Project	IEEE 802.16 Broadband Wireless Access Working Group < <a href="http://ieee802.org/16">http://ieee802.org/16</a> >	
Title	Secondary fast feedback channel and UL ACK channel in OFDMA	
Date Submitted	2005-01-10	
Source(s)	Bin-Chul Ihm, Yongseok Jin, Jinyoung Chun	Voice: 82-31-450-7187 Fax: 82-31-450-7912 <a href="mailto:{bcihm, jayjay, jychn03}@lge.com">[mailto: {bcihm, jayjay, jychn03}@lge.com]</a>
	LG Electronics, Inc. 533,Hogye-1dong, Dongan-gu, Anyang-shi, Kyongki-do, Korea	
Re:	This is a response to a Call for Comments on IEEE P802.16e-D5a	
Abstract	Pilot carriers can be used as secondary Fast-feedback channel or secondary UL ACK channel in OFDMA	
Purpose	This document is submitted for review by 802.16e Working Group members	
Notice	This document has been prepared to assist IEEE 802.16. It is offered as a basis for discussion and is not binding on the contributing individual(s) or organization(s). The material in this document is subject to change in form and content after further study. The contributor(s) reserve(s) the right to add, amend or withdraw material contained herein.

# Secondary fast feedback channel and UL ACK channel in OFDMA

**Figure zzz —Subcarrier Mapping of Secondary Fast-feedback Modulation Symbols for PUSC**

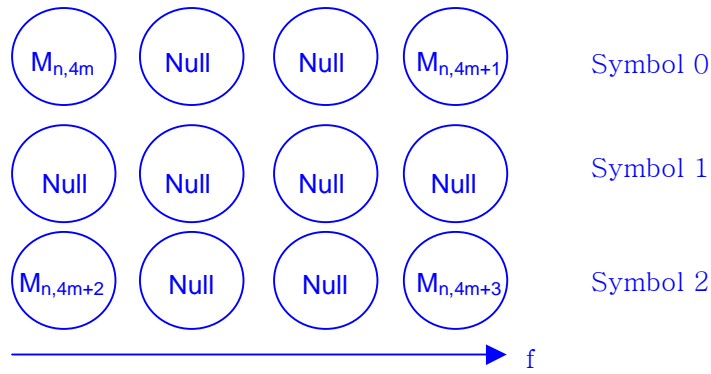
$M_{n,4m+k}$  are mapped to secondary Fast-feedback channel tile as shown in Figure zzz for PUSC uplink subchannel. A secondary Fast-feedback channel is mapped to one subchannel composed of 6 tiles.

**Figure aaa— Mapping order of Fast-feedback messages to the Fast-feedback region when using secondary Fast-feedback in UL PUSC mode**

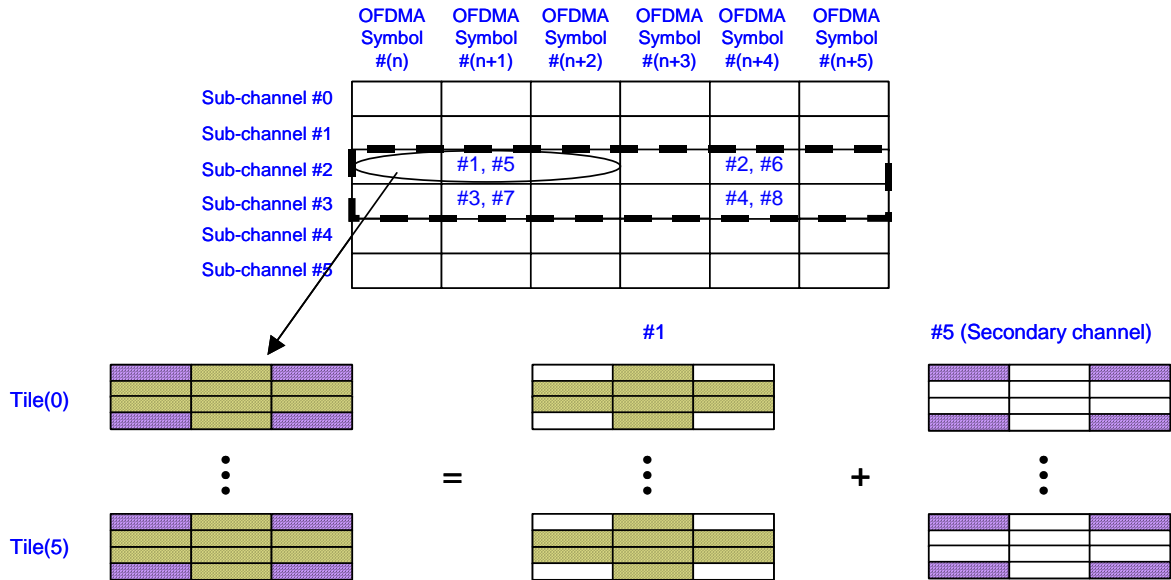
The secondary Fast-feedback slot includes 4 bits of payload data, whose encoding depended on the instruction given in the FAST\_FEEDBACK Fast-feedback subheader, the CQICH\_Control IE(), the CQICH\_Alloc\_IE(), or through the CQICH\_Enhanced\_Alloc\_IE(). Secondary Fast-feedback slots are mapped into the region marked by UIUC=0 in the UL-MAP after mapping the whole Fast-feedback slot, in a time-first order, as shown in Figure aaa.

**Figure 231b—Subcarrier Mapping of UL ACK Modulation Symbols for PUSC**

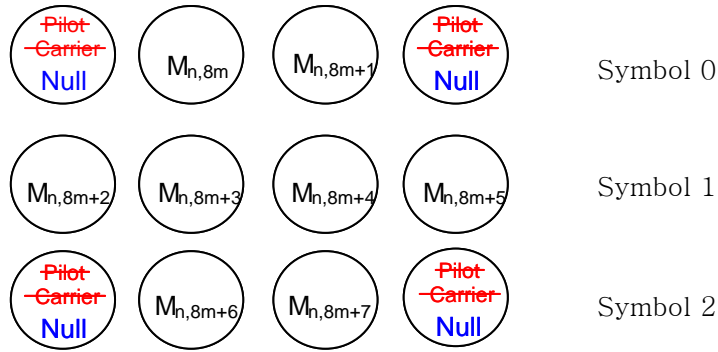
[Modify the Figure 231b in page 274 of ‘8.4.5.4.17 Optional Enhanced UL ACK channels’ as following]

**Figure 231d —Subcarrier Mapping of Secondary UL ACK Modulation Symbols for PUSC**

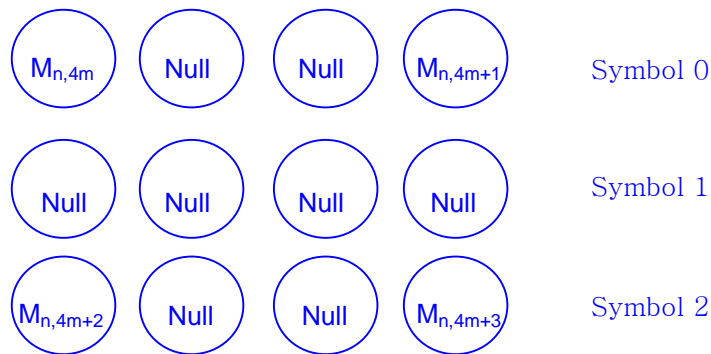
$M_{n,4m+k}$  are mapped to secondary UL ACK channel tile as shown in Figure 231d for PUSC uplink subchannel. Secondary UL ACK channel is mapped to half subchannel composed of 3 tiles.
